ADDENDUM NO. 4

**Indianapolis International Airport
Indianapolis, Indiana**

Belly Cargo/GSE Maintenance Building

IAA Project No. I-09-033-B

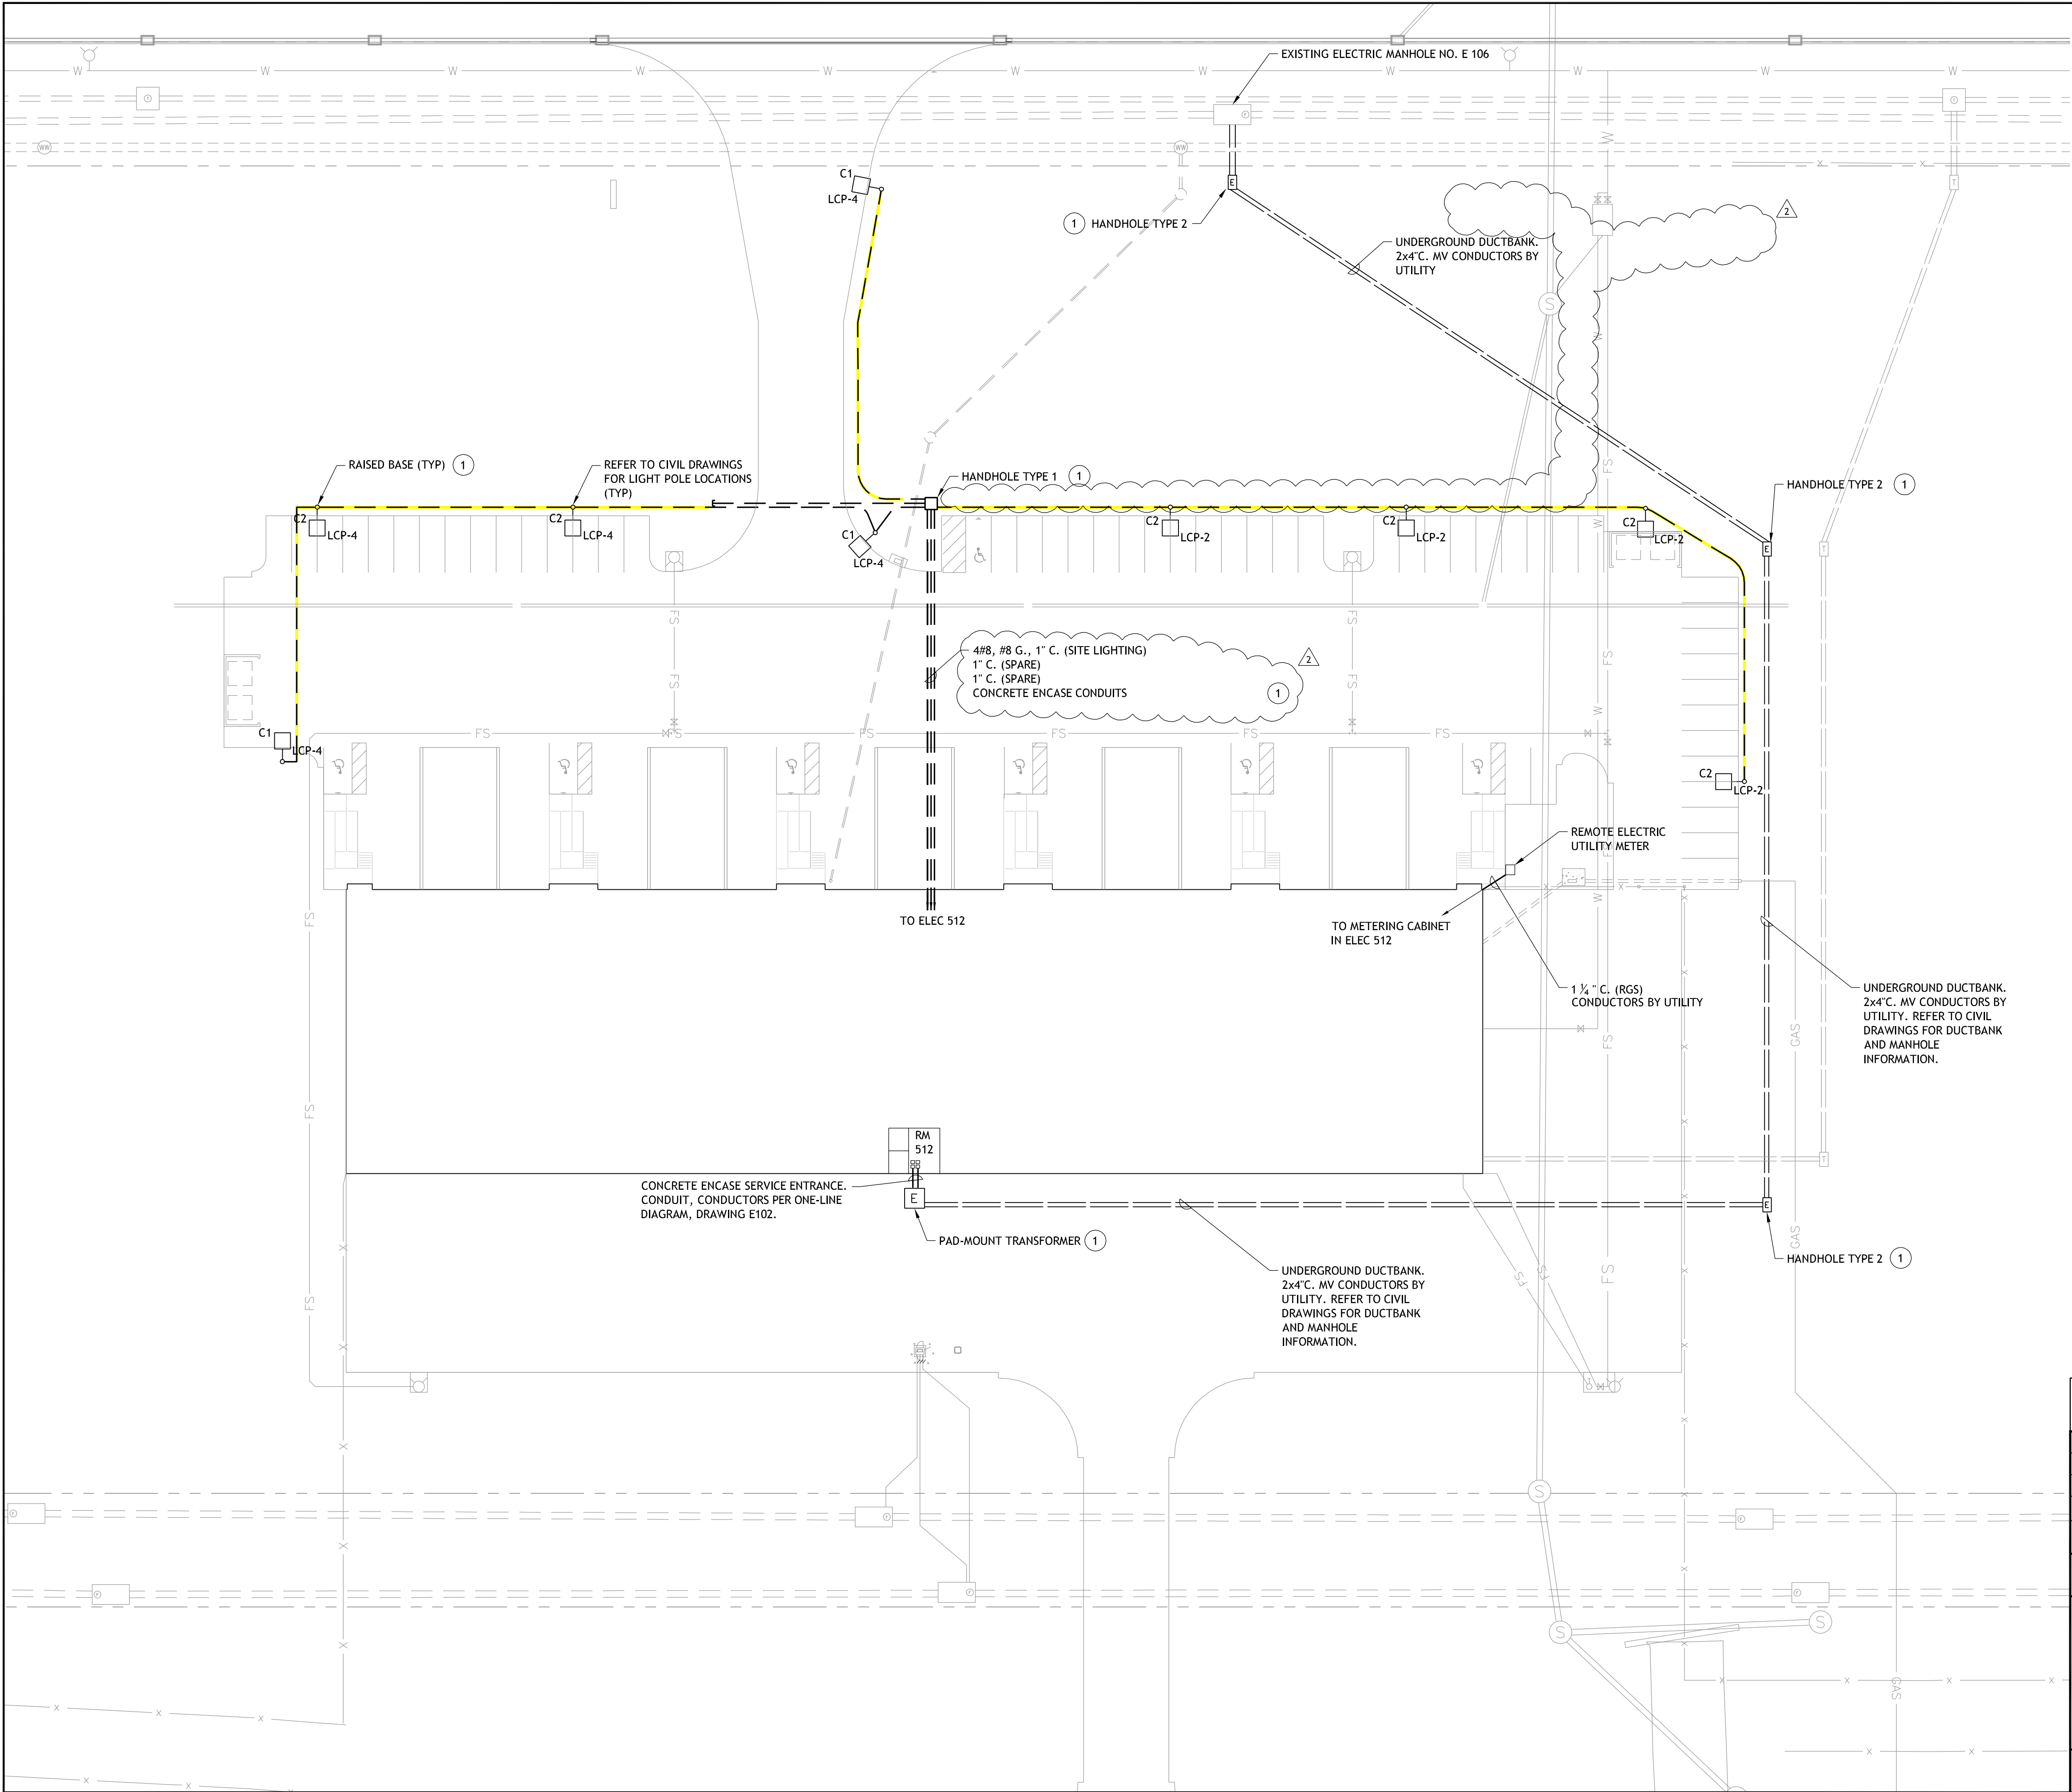
PLAN SHEET E101 – ELECTRICAL SITE PLAN

- Delete: Plan Sheet E101 dated 10/16/09.
- Insert: Plan Sheet E101 revised 11/16/09, attached.
(Revised extent of conduit concrete encasement).
